ECN/PCN No.: 3500

Product Description: CERAMIC SMD CRYSTAL	Abrakon Part Number / Part Series: ABM8	<input checked="" type="checkbox"/> Series <input type="checkbox"/> Part Number
Affected Revision: Rev. AA	New Revision: Rev. AB	Application: <input type="checkbox"/> Safety <input checked="" type="checkbox"/> Non-Safety

1. Mechanical Dimensions & Tolerances (Bottom View)

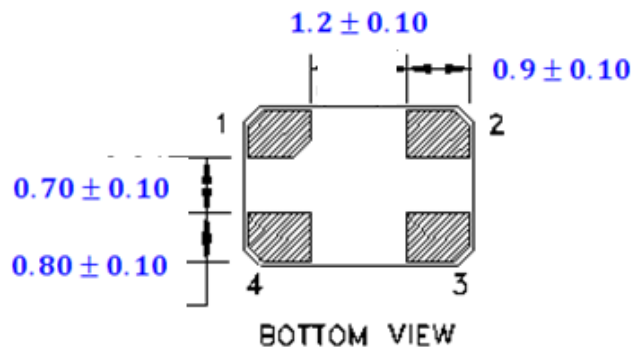
Standard product series review and upgrade. Due to SMD package material availability, product mechanical dimensions and tolerances were adjusted, a revised landing pattern was implemented to increase ease of soldering, and an alternate pad is utilized for the chamfer pad location.

Change Declaration:
Mechanical Dimensions and Tolerances:

The package mechanical dimension revisions do not impact the mechanical performance of the device.

2. Landing Pattern

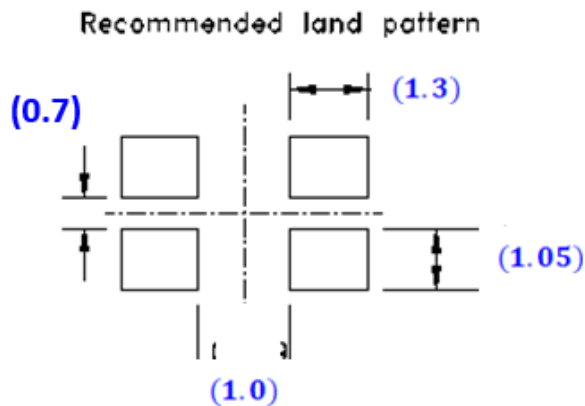
PCB Landing Pattern:

There is no impact on the PCB layout/landing pattern for customer's existing boards. The new landing pattern was implemented to increase ease of soldering.

3. Chamfer Location

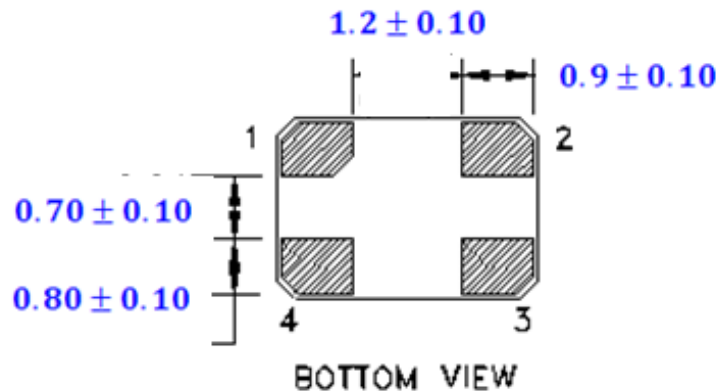
Due to material availability, the chamfer could be located on pin #1, 3, or 4. Be advised that the chamfer location has no impact on the electrical performance of the device.

Chamfer Location:

The package chamfer pad location revision does not impact the mechanical or electrical performance of the device.
